1 **PWU INTERROGATORY #1**

4 A-02-04-01 p. 6-7

Figure 1 - Number of Assets beyond ESL per Year Summary

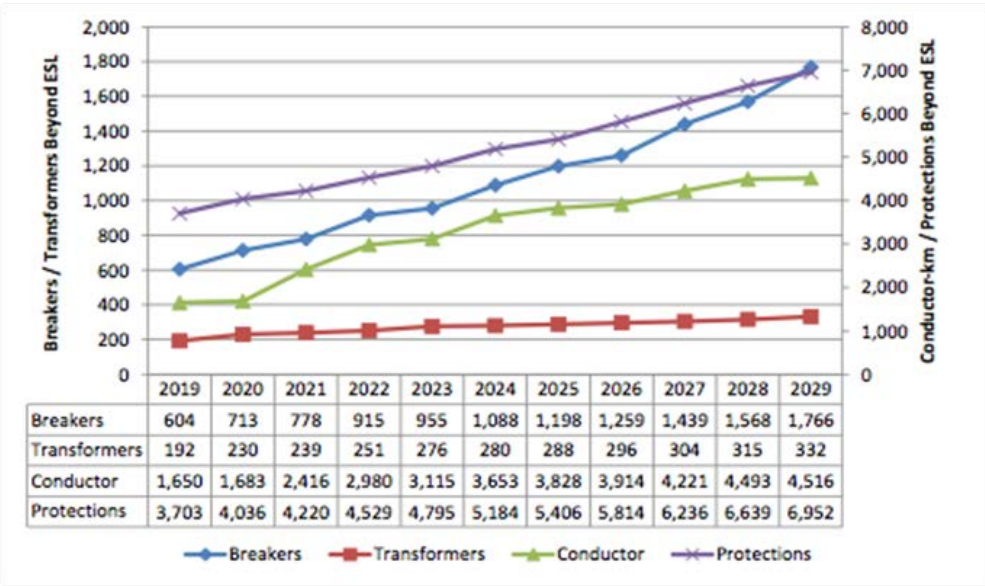
- a) The PWU’s understanding is that the deferral of capital investments would typically create pressure on OM&A costs. Please explain how HO’s proactive and strategically paced investments can prevent pressure on both OM&A and capital costs at the same time.
- b) Please reproduce the table in Figure 1 (for the 2019-2024 period) indicating the percentage or share that the ESL numbers represent.

2 a) Hydro One's paced investments are selected through the comprehensive Investment
3 Planning Process documented in Exhibit B-1-1 TSP Section 2.1 to identify, prioritize
4 and optimize investments to manage costs and asset/system operational risks. This
5 process is designed to ensure that the highest priority investments are implemented,
6 considering multiple perspectives, to support Hydro One's business objectives and
7 deliver outcomes valued by customers. The figure presented above indicates the
8 resulting proportion of assets beyond ESL, in absence of investment. Hydro One's
9 plan seeks to prevent increased pressures associated with the aging asset base with
10 consideration to customer rate impacts.

11
12 b) See Table 1 below for the percentage of assets operating beyond ESL as it relates to
13 Figure 1 from TSP Section 2.2.

Table 4

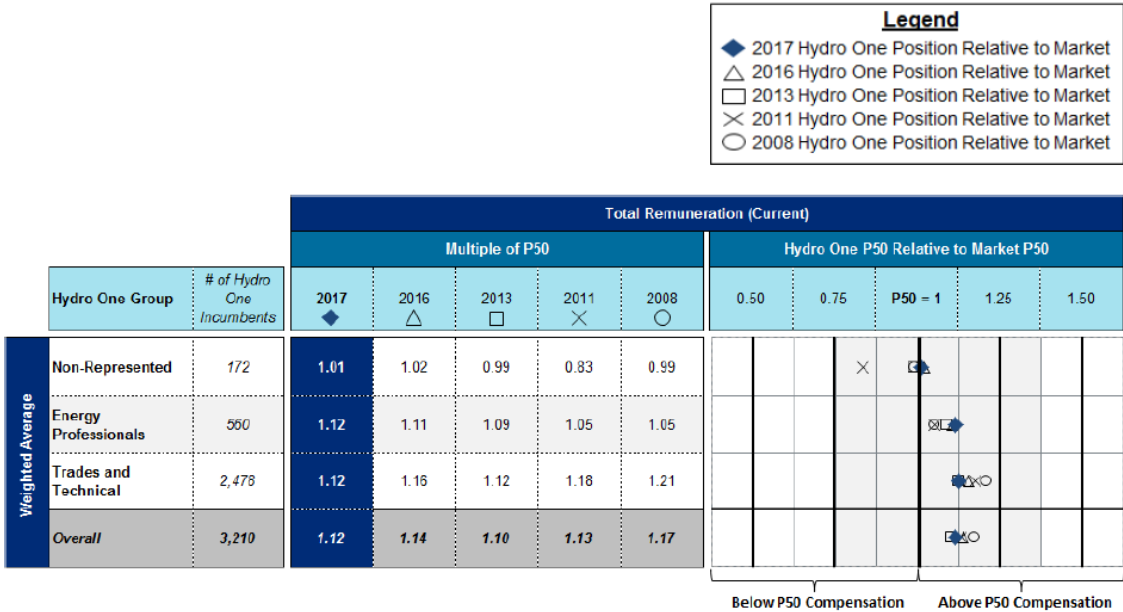
- 1 a) Why is Mercer only able to benchmark 2,478 PWU incumbents and Willis Towers
- 2 Watson is able to benchmark 4,244 PWU incumbents?
- 3
- 4 b) Which positions was Willis Towers Watson able to benchmark that Mercer was not?
- 5
- 6 c) Is it Hydro One's opinion that Willis Towers Watson's study is more reflective of
- 7 Hydro One's relative compensation because it encompasses a much greater share of
- 8 its employees? Please explain.
- 9

20
21 c) In Hydro One's opinion, both studies are reflective of the market and are intended to
22 serve different purposes. The Mercer study is intended to provide targeted data on
23 specific highly populated positions, while the Willis Towers Watson Study is
24 intended to provide a view on PWU more broadly. In addition, Willis Towers Watson
25 study focuses on total target cash compensation, whereas the Mercer study is based
26 on total remuneration.

Figure 10 – Number of Assets Beyond End of Service Life Per Year Summary

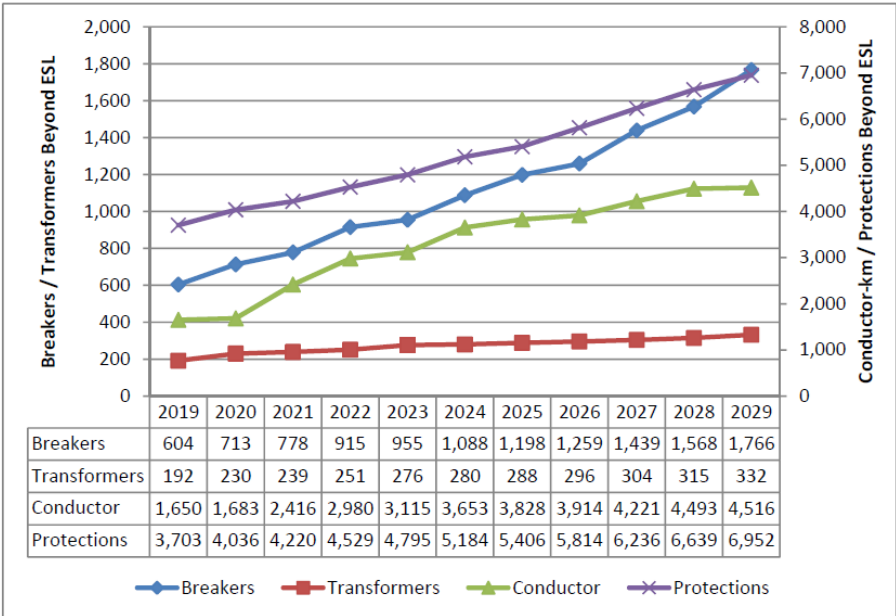
a) What is the demographic profile at the end of the rate period assuming the plan is completed?

a) See TSP Section 3.1, Figure 2 for the demographic profile of breakers, transformers, conductor, and protections following the completion of the 2020-2024 Transmission System Plan. The demographic profile following the completion of the plan over 2020-2022 is as follows:

Figure 3-2 shows the number of transformers by vintage.

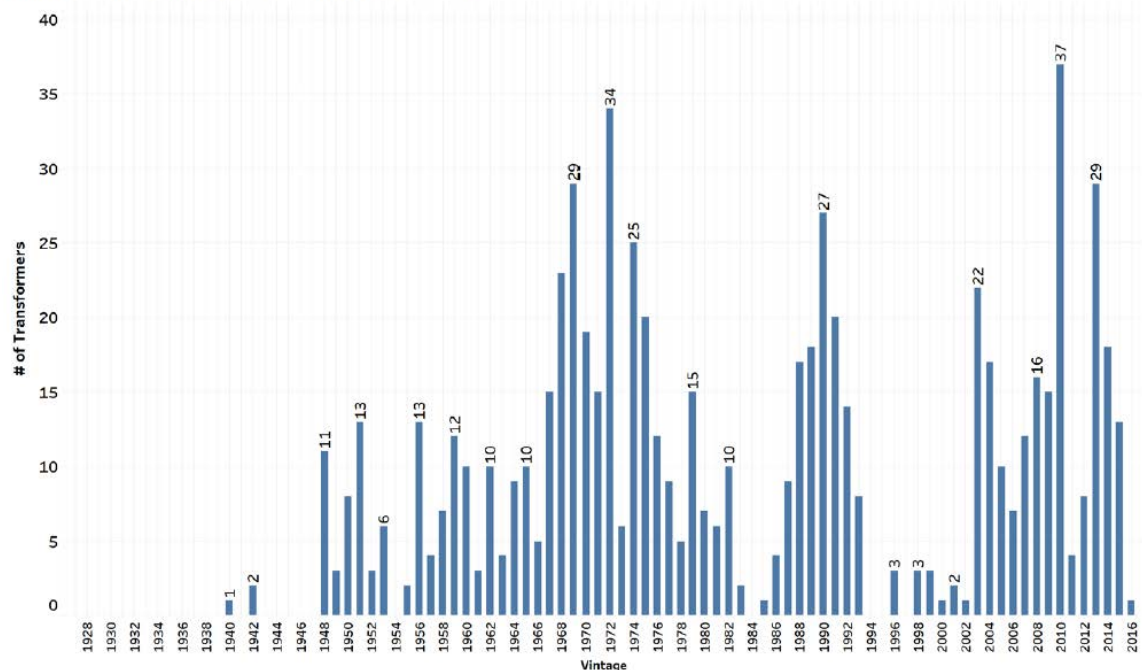
a) What will this chart look like at the end of the test period?

a) The number of transformers with high condition risk factors from the 1970's and earlier vintages, is higher than ones built after 1970. After planned removal of these high condition risk factor transformers, the spikes on the chart prior to the 1970's will be smoothed out.

Figure 4-6 shows long-term and short-term risk for Hydro One’s 230 kV units using the five-category ranking.

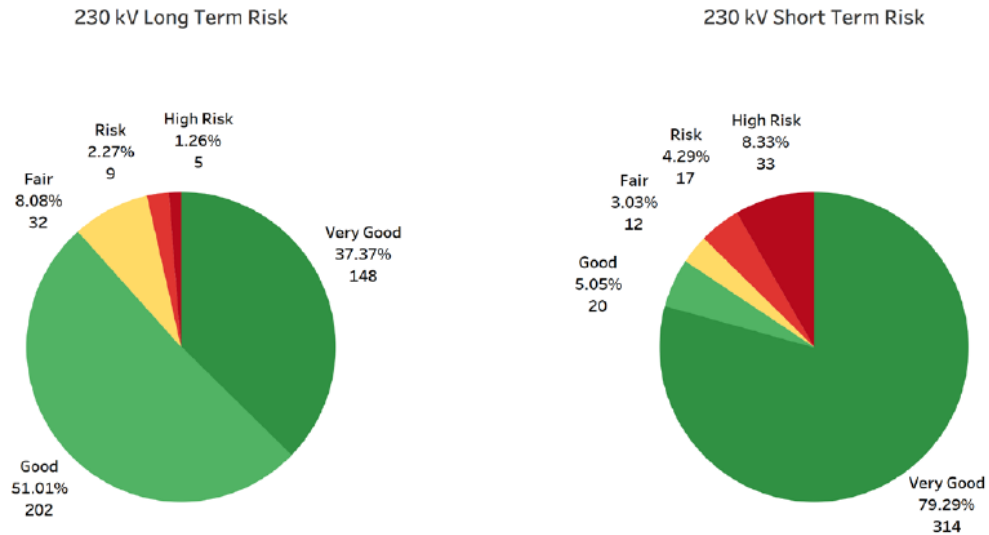
- a) What does “short term” and “long term” mean in this context?
- b) Please define “high-risk”. Is it a measure of the probability of failure? If so, what is the threshold?

- a) Please refer to Interrogatory I-05-CME-18.
- b) High risk means there are signs of internal transformer problems that require a timely response. If confirmed by further testing, consideration will be given to remove the unit from service.
